## 7.2 Reactor Protection (Trip) System (RPS)—Instrumentation and Controls

The information in this section of the reference ABWR DCD, including all subsections, tables and figures, is incorporated by reference with the following departures and supplements.

Figure 7.2-2 Reactor Protection System Equipment Arrangement (From Sensors Through Trip Actuators)

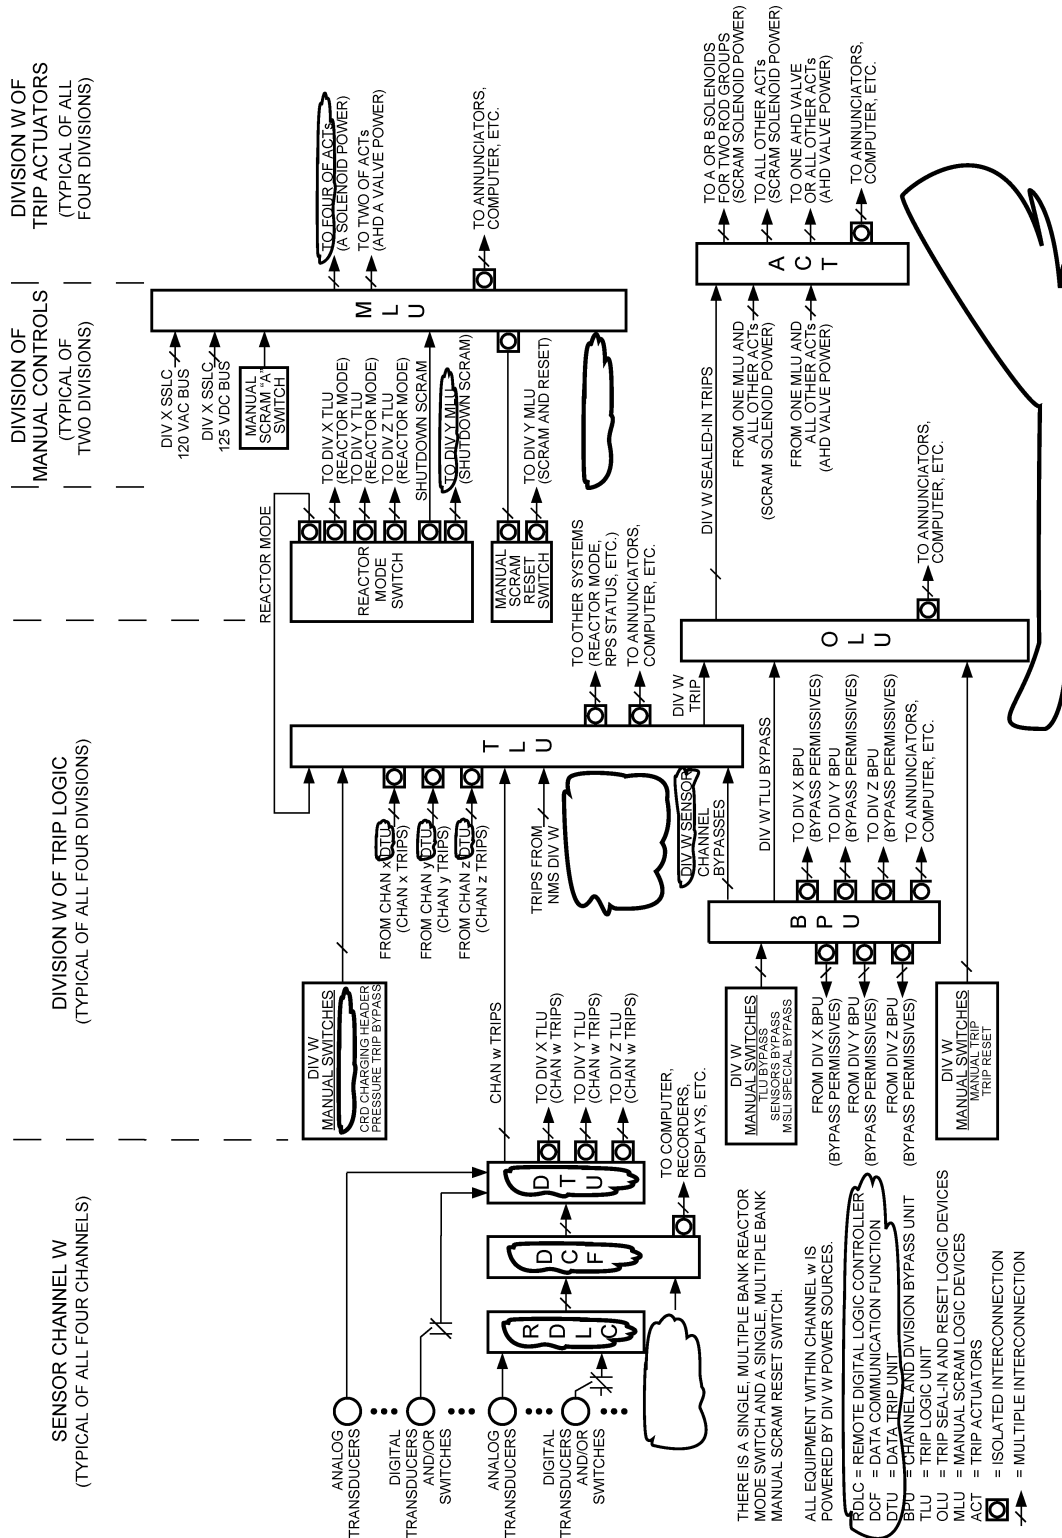
*The RPS equipment is divided into four redundant divisions of sensor (instrument) channels, trip logics and trip actuators, and two divisions of manual scram controls and scram logic circuitry. The sensor channels, divisions of trip logics, divisions of trip actuators and associated portions of the divisions of scram logic circuitry together constitute the RPS scram and air header dump (backup scram) automatic initiation logic. The divisions of manual scram controls and associated portions of the divisions of scram logic circuitry together constitute the RPS scram and air header dump manual initiation logic. The automatic and manual scram initiation logics are independent of each other. RPS equipment arrangement is shown in Figure 7.2-2.*

*Equipment within a sensor channel includes primarily sensors (transducers or switches), ~~multiplexers~~ data communication equipment and digital trip modules (DTMs) ~~trip units (DTUs)~~. The sensors within each channel monitor plant variables (Subsection 7.2.1.1.4.2) send either analog or discrete output to ~~remote multiplexer units (RMUs)~~ Remote Digital Logic Controllers (RDLCs) within the associated division of ~~Essential Multiplexing System (EMS)~~ data communication. Each division of the EMS data communication performs analog-to-digital conversion on analog signals and sends the digital or digitized analog output values of all monitored variables to the ~~DTM DTU~~ within the associated RPS sensor channel. The ~~DTM DTU~~ in each sensor channel compares individual monitored variable values with trip setpoint values and for each variable sends a separate, discrete (trip/no trip) output signal to all four divisions of trip logics.*

~~for digital systems, and signal distribution are performed by the RDLCs. RMUs is a function of the EMS and is discussed in Section 7A.2.~~

Four independent sensor channels monitor the various process variables listed in Subsection 7.2.1.1.4.2. The redundant sensor devices are separated so that no single failure can prevent a scram. The arrangement of RPS sensors mounted in local racks is shown in Figure 7.2-2. Locations for local RPS racks and panels are shown on the instrument location drawings provided in Section 1.7. Divisional separation is also applied to the ~~Essential Multiplexing System (EMS)~~ Data Communication for RTIS, which provides data highways for the sensor input to the logic units. Physically separated cabinets are provided for the four scram logics. Fiber optic cable routing

either from ~~remote multiplexing units (RMUs)~~ ~~remote digital logic controllers (RDLCs)~~ or directly to control room equipment is shown in raceway plans provided by reference in Section 1.7. The criteria for separation of sensing lines and sensors are discussed in Section 7.1.

Figure 7.2-5 Division 1 Trip Logic Coincident and Non-Coincident NMS Trips

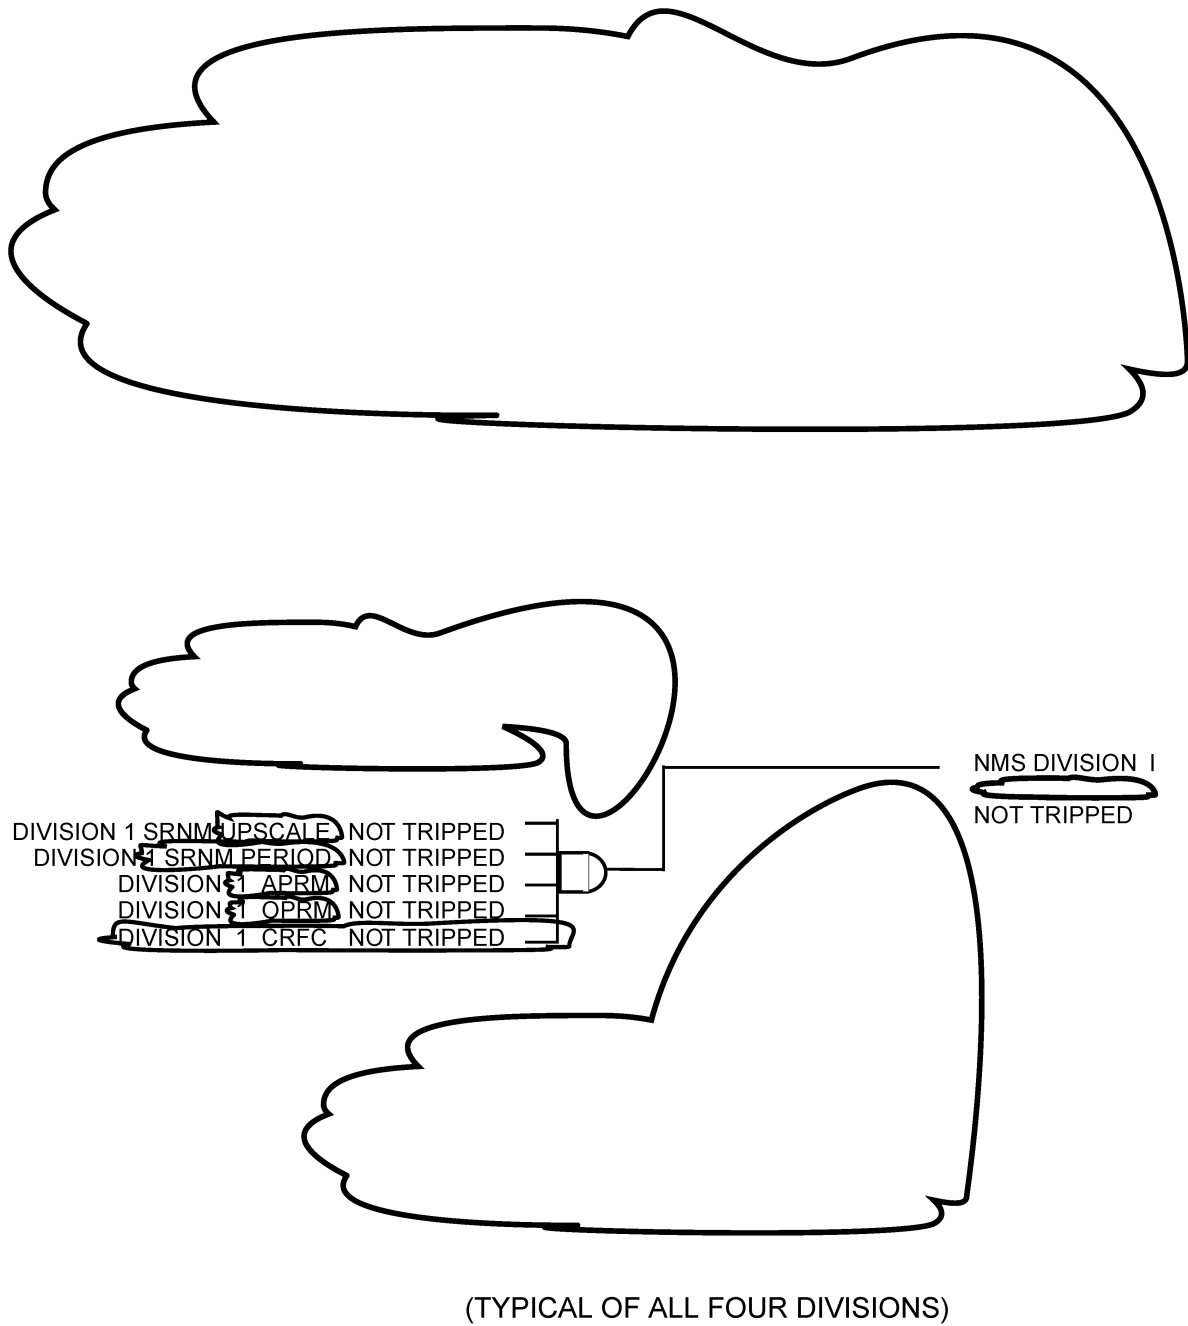
STD DEP 7.2-1 (Figure 7.2-5, 7.2-9, 7.2-10)

*Each of the four divisions of the NMS equipment provides separate, isolated, ~~bistable~~ SRNM trip and APRM trip signals to ~~all four divisions~~ the corresponding division of RPS trip logics (Figure 7.2-5).*

*Neutron Monitoring System Trips (Figure 7.2-5)*

~~A coincident~~ An NMS trip will occur in each division of trip logic when ~~any two or more out of four divisions of~~ APRM or SRNM trip signals are received from the NMS. The ~~coincident~~ SRNM trip is automatically bypassed when the reactor is in the run mode. The coincident APRM trip cannot be bypassed.

~~A non-coincident NMS trip will occur in each division of trip logic when any single APRM or SRNM trip signal is received from the NMS. The non-coincident NMS trip is automatically bypassed when the reactor is in the run mode. When the reactor is in the shutdown, refuel or startup mode, the non-~~

~~coincident NMS trip can be manually bypassed in each division by a separate, manual, keylock non-coincident NMS trip disable switch.~~
